**US OIL RECOVERY SUPERFUND SITE
WORK PLAN REFINEMENT/MODIFICATION NOTICE**

WORKPLAN REFINEMENT/MODIFICATION NOTICE NO.: AO1-1-5

DATE: June 9, 2017

Figure 1

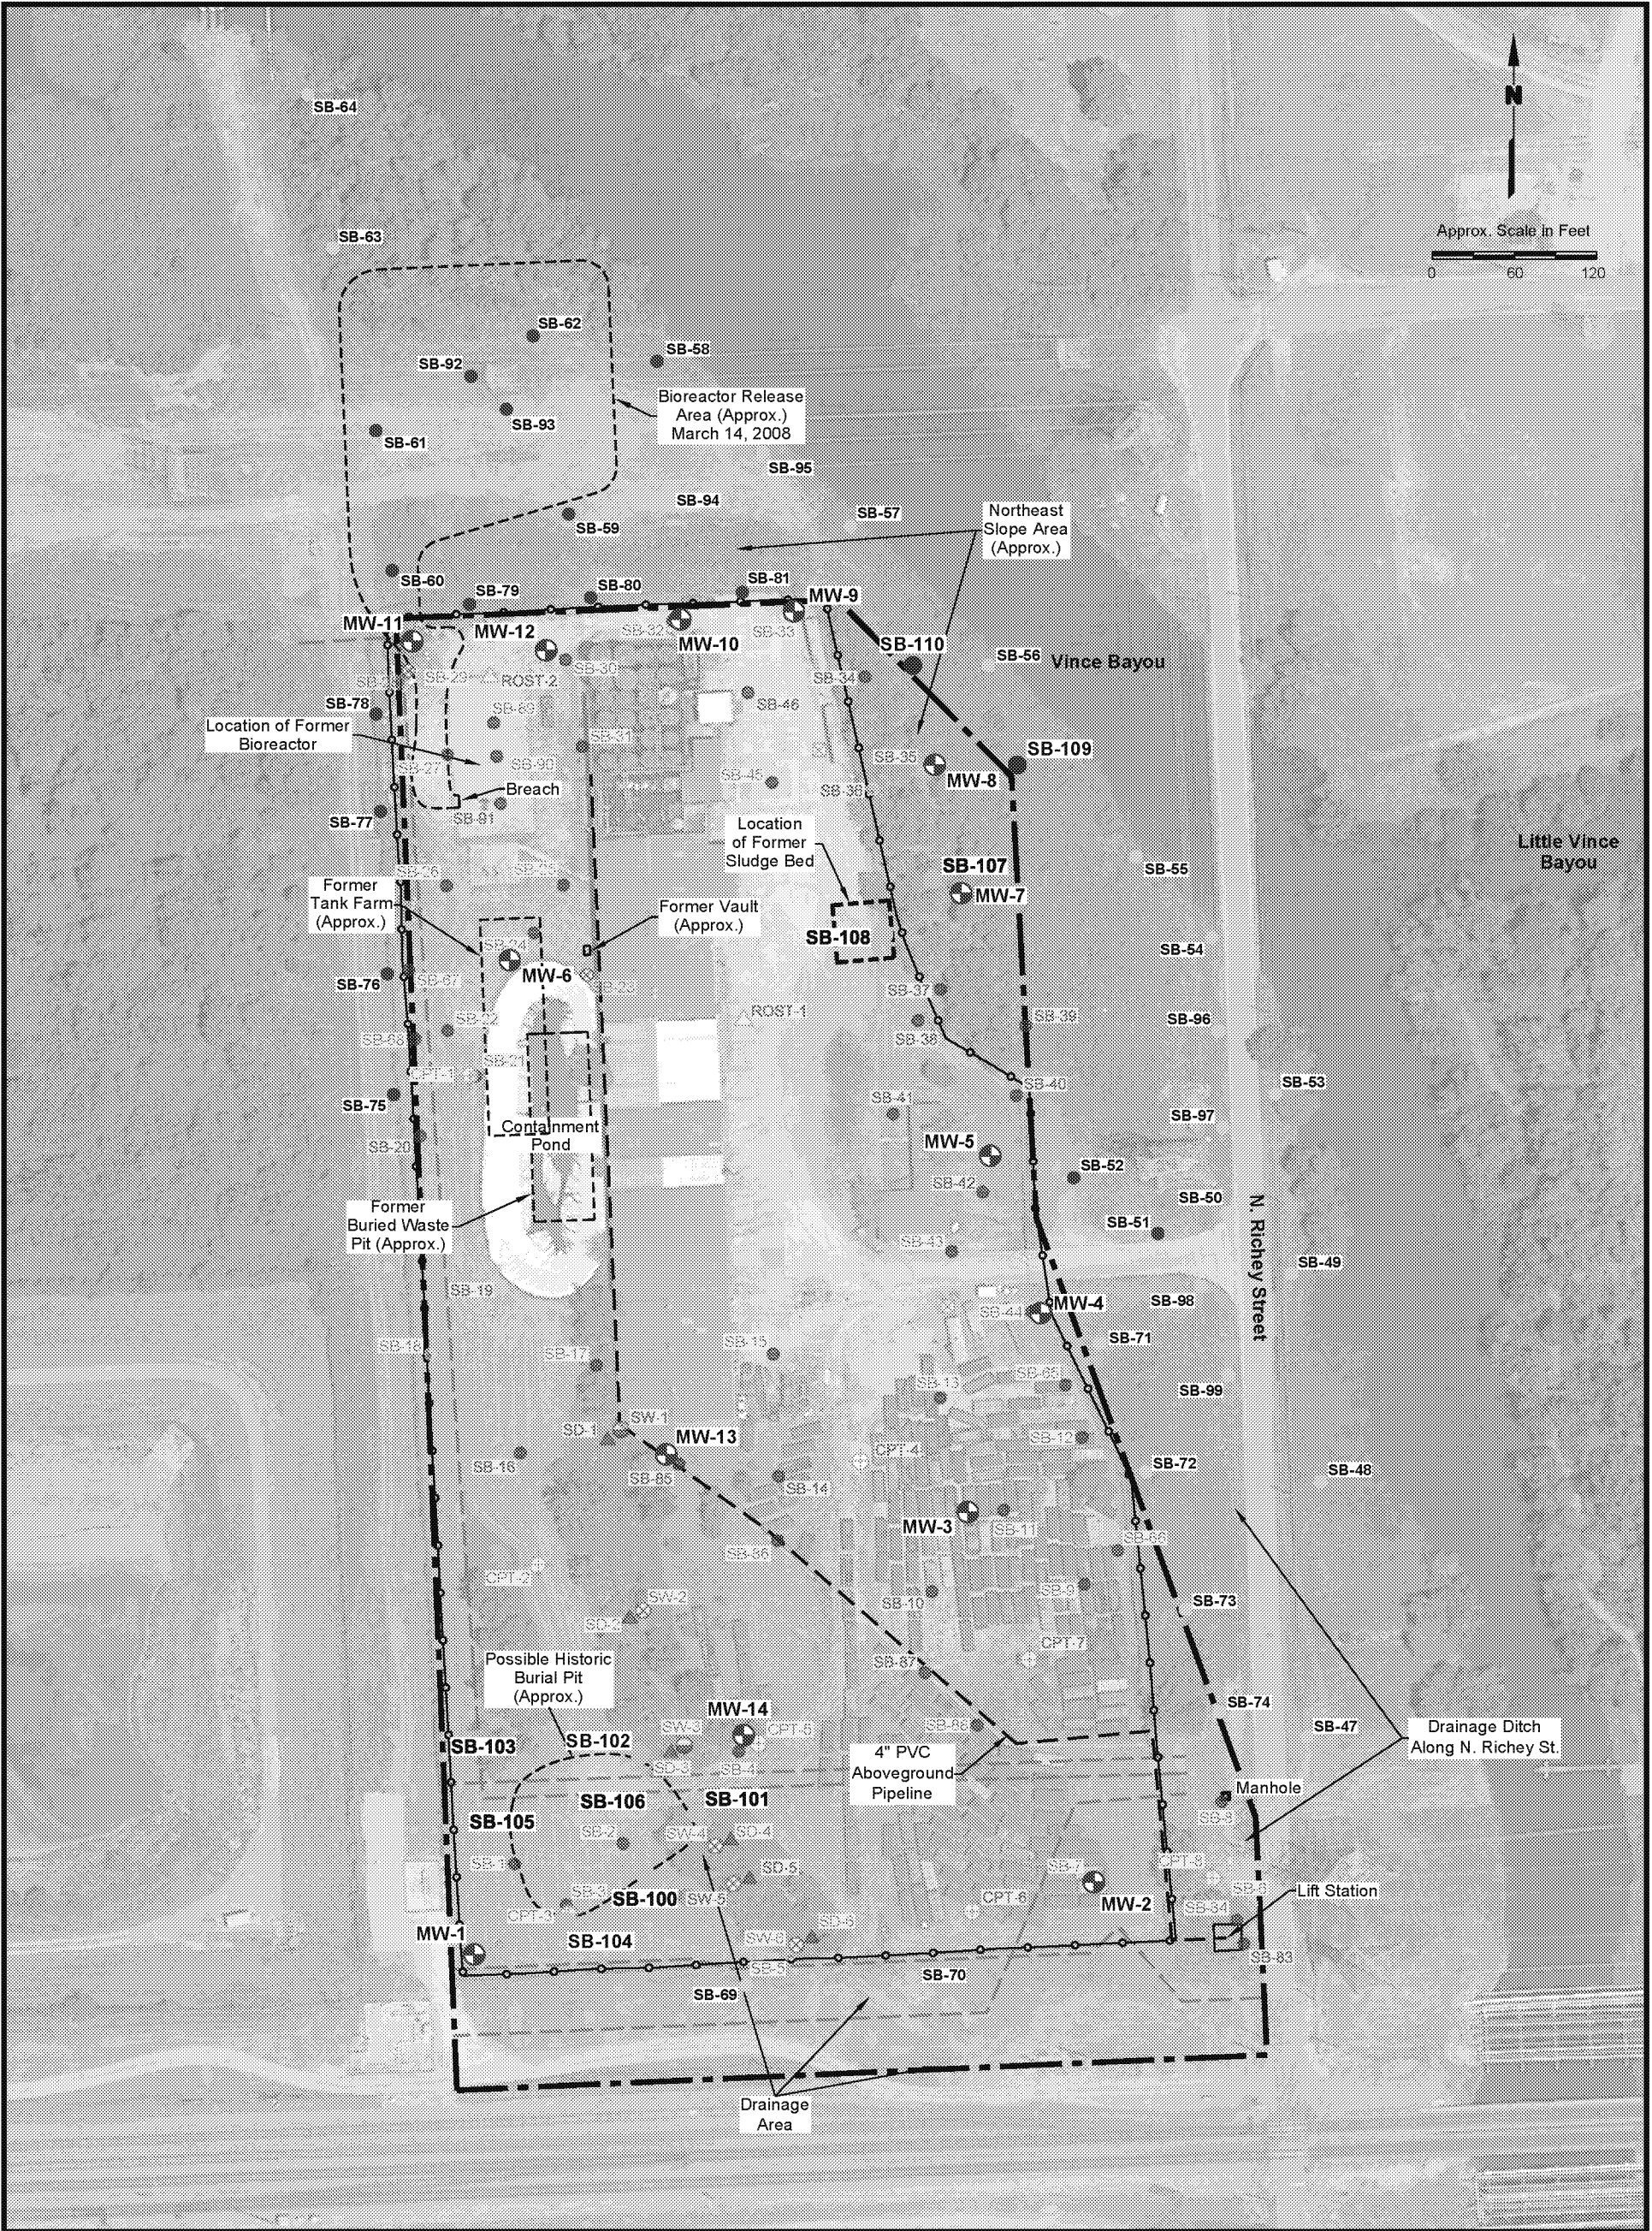
Based on soil sample concentration data for chemicals of potential concern (COPC) and observations collected to date, the locations of the following four monitoring well locations are proposed to be adjusted from the locations proposed in the RI/FS Work Plan (Figure 1). Specifically:

- MW-1 is proposed to be moved to the southwestern-most corner of the Site, outside of the projected historic burial pit boundary, to be upgradient of potential on-site source areas in the main operational area and the possible historic burial pit area;

- MW-6 is proposed to be moved approximately 90 feet to the northeast of the original location to evaluate potential groundwater issues related to soils in the Former Tank Farm area;

- MW-7 is proposed to be moved approximately 75 feet northwest of its original location proposed in the RI/FS Work Plan to adjust the monitoring well spacing, to evaluate potential groundwater impacts of metal, pesticide and herbicide, volatile organic compound (VOC), semi-volatile organic compound (SVOC), and total petroleum hydrocarbon (TPH) concentrations that exceeded soil preliminary screening values (PSVs) in soil samples collected in the area (e.g., soil boring SB-37), and to evaluate potential impacts from the former sludge bed;

- MW-8 is proposed to be moved approximately 50 feet northeast of its original location proposed in the RI/FS Work Plan to adjust monitoring well spacing and to evaluate potential groundwater impacts of metal, pesticide and herbicide, VOC, SVOC, and TPH concentrations that exceeded soil PSVs in soil samples collected in the area (e.g., soil borings SB-34, SB-35, and SB-36).

In addition, MW-11 may be re-located slightly due to the presence of equipment in the area and/or to avoid a pipeline located near the original proposed location. If the monitoring well is re-located, best efforts will be made to keep the location near the original location and within the former bioreactor release area shown on Figure 1.

Three additional monitoring wells are proposed to evaluate potential groundwater impacts in source areas, based on data collected to date. Specifically:

- MW-12 is proposed to evaluate potential groundwater impacts of metal, pesticide and herbicide, VOC, SVOC, and TPH concentrations that exceeded soil PSVs in soil samples collected in the area (e.g., soil borings SB-30 and SB-89);
- MW-13 is proposed to evaluate potential groundwater impacts of VOC concentrations that exceeded soil PSVs in soil samples collected in the area (e.g., soil borings SB- 17 and SB-85); and
- MW-14 is proposed to evaluate potential groundwater impacts from the possible historic burial pit, which has been identified with impacts of metal, pesticide and herbicide, VOC, SVOC, and TPH concentrations that exceeded soil PSVs in soil samples collected in the area (e.g., soil borings SB-2 and SB-3).

To investigate concentrations of metal, pesticide and herbicide, VOC, SVOC, and TPH that exceeded soil PSVs in soil samples collected at the northeast slope area immediately outside the property boundary, two additional source area soil borings, SB-109 and SB-110, are proposed (Figure 1). In addition, two soil borings at the southern property boundary, SB-69 and SB-70, are proposed to be moved slightly to the north to avoid significant pipeline easements at the originally proposed locations. These additional proposed borings and adjusted boring locations are shown on Figure 1.
